# Bridge Square

Northfield Heritage Preservation  
Commission Meeting

December 4, 2024 | 6:00pm

60%  
Plans  
and 90%  
plans

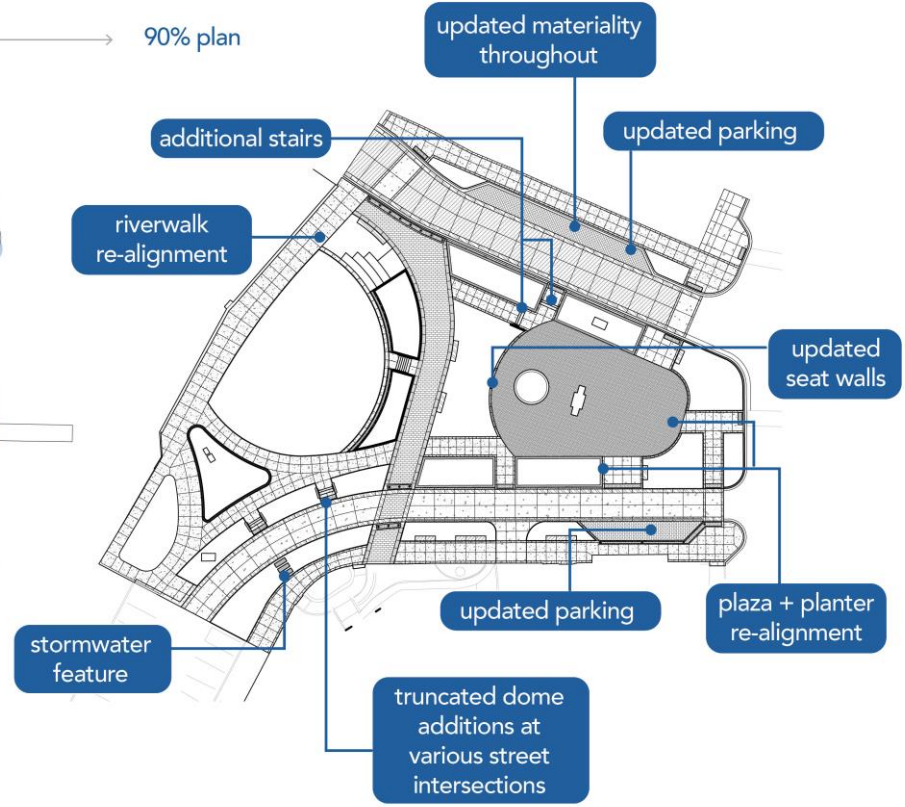
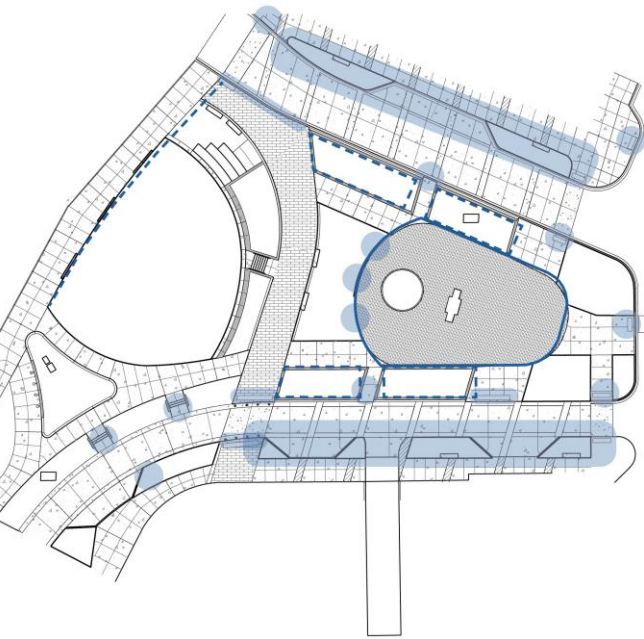
Based on our review of the submitted documentation, we are pleased to see that the **design has been refined in response to comments received from our office, the Northfield Heritage Preservation Commission, and Northfield community members.**

In our opinion, the current design is much more compatible with the forms of both Riverside Park and Bridge Square, and we have determined that **the project, as currently proposed in the 60% construction documents, has been designed in accordance with the SOI Standards.** We look forward to reviewing the 90% construction documents when

90%  
Plans

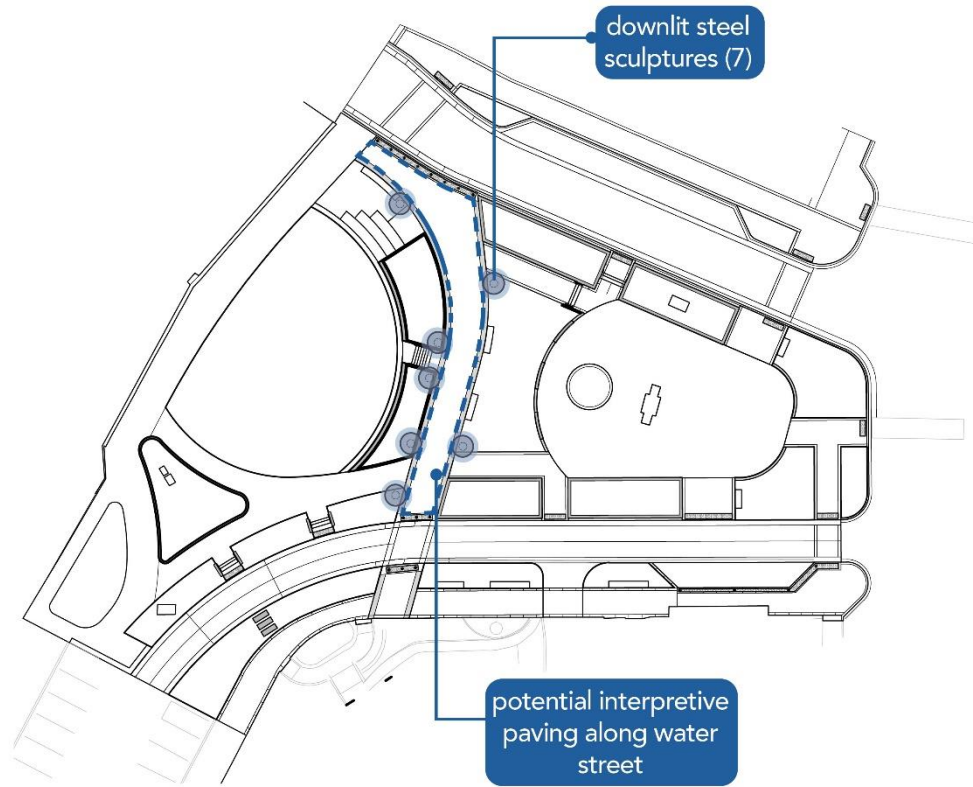
- Per SOI for rehabilitation: primary focus is on viewsheds, materials, and installation
- Sculptures
  - Not nearly as tall as the existing trees located within the same area of the park in which they are proposed to be installed.
  - Lit in similar fashion to the lighting plan for the entire park, all of which is in accordance with the City of Northfield's Land Development Code Outdoor Lighting Standards, which follow Minnesota Statute 16B.328, the state law regulating light pollution.
  - May require the installation of footings four feet in depth
  - Locations at the south are within the site boundaries of 21RC0076
    - Could potentially disturb resources if the footing is reaching a depth of more than four feet below the surface.
    - Monitoring Plan in place for the entire site.

- Per SOI for rehabilitation: primary focus is on viewsheds, materials, and installation
- Pavers
  - Will not adversely affect the existing landscape slope of the park or the existing, historic viewshed of the Cannon River from Bridge Square.
  - Will not disrupt the landscape slope or viewshed, nor remove or alter existing materials.

Regarding the public art, we understand that the **Northfield Arts and Culture Commission approved** the public art elements in early July. Although the proposed structures are relatively tall, **we agree that their general scale and location within the park along Water Street should not adversely affect the historic landscape/viewsheds.** We also agree that the proposed **etched granite pavers will not adversely affect the historic property.**

60%  
Plans  
to 90%  
Plans

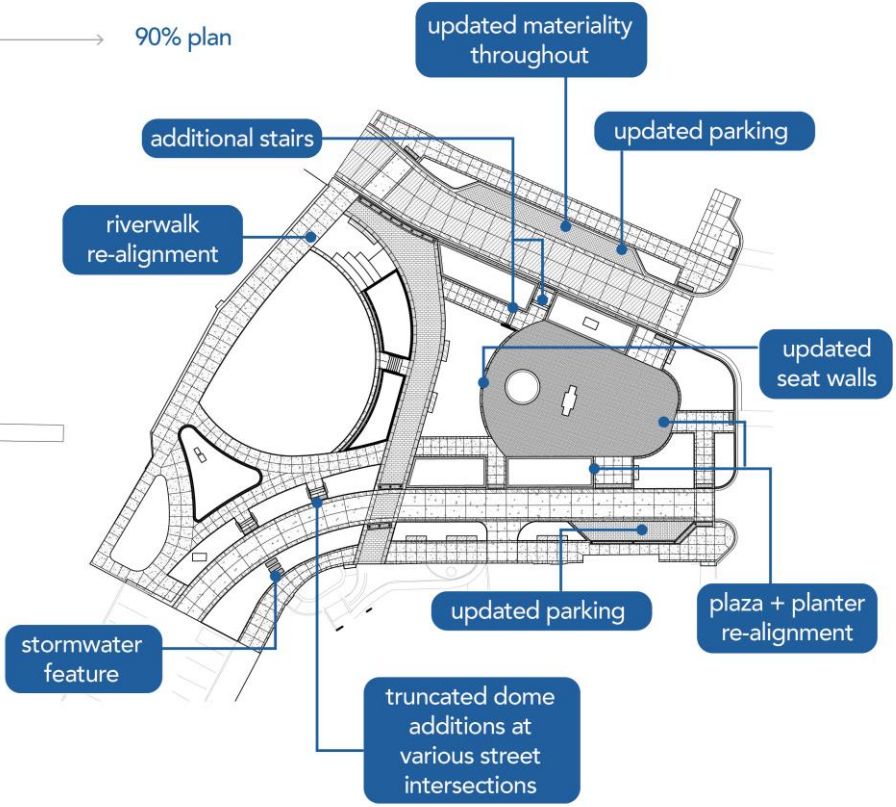
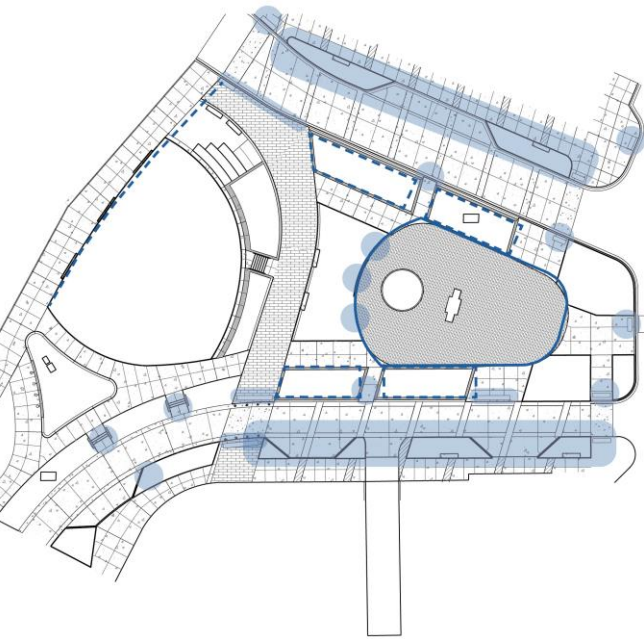
Nothing in the 90% plans requires the removal of distinctive materials or alteration of features, spaces, and spatial relationships that characterize Bridge Square

Figure 7

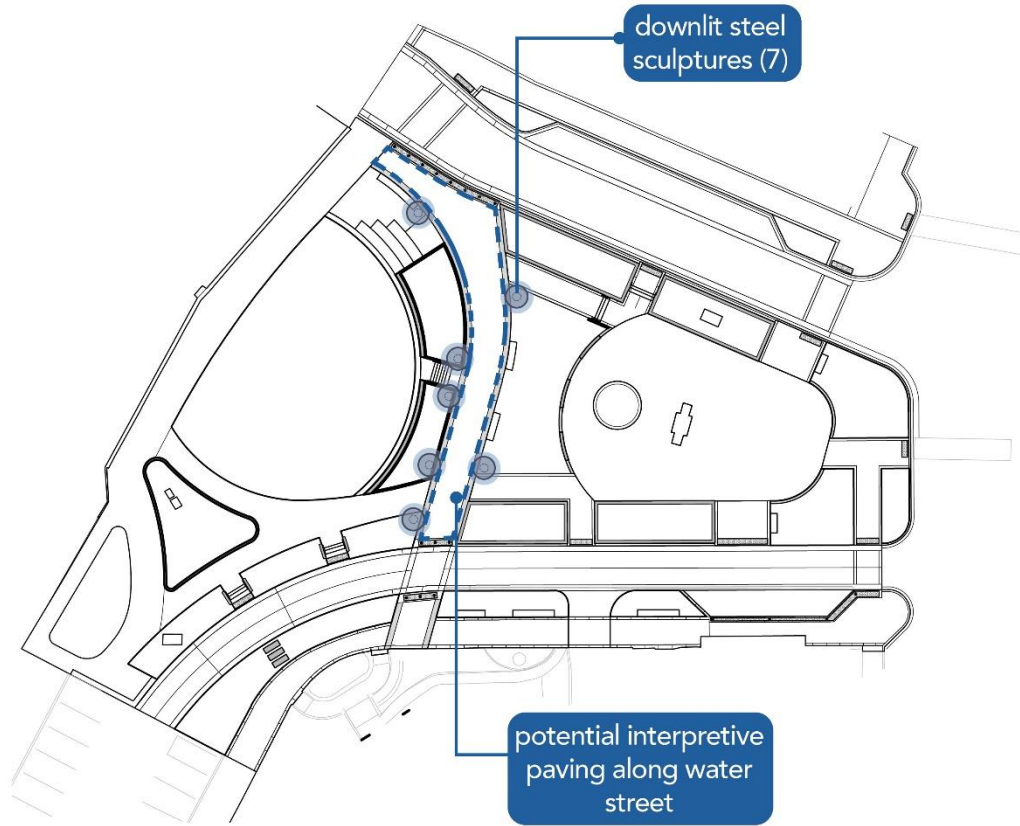
- Potential mitigation measures for any unanticipated discovery that occurs during construction of the current park designs and/or the installation of the proposed public art.
- For the purposes of the Archaeological Monitoring and Unanticipated Discoveries Plan, archaeological site 21RC0076 (historical surface of the 1856 Mill Square) will be considered both a contributing resource to the Northfield Commercial Historic District and a potential individually

One archaeological site, site 21RC0076, has been identified within the project area. We consider this site to be a contributing resource to the Northfield Commercial Historic District. The site may also have individual significance. We agree that **archaeological monitoring** should be conducted during project construction, as well as during installation of the proposed public art. We understand that the 106 Group will draft an **Archaeological Monitoring and Unanticipated Discoveries Plan** (Plan) that will include potential mitigation measures for any unanticipated discovery that occurs. We look forward to reviewing the
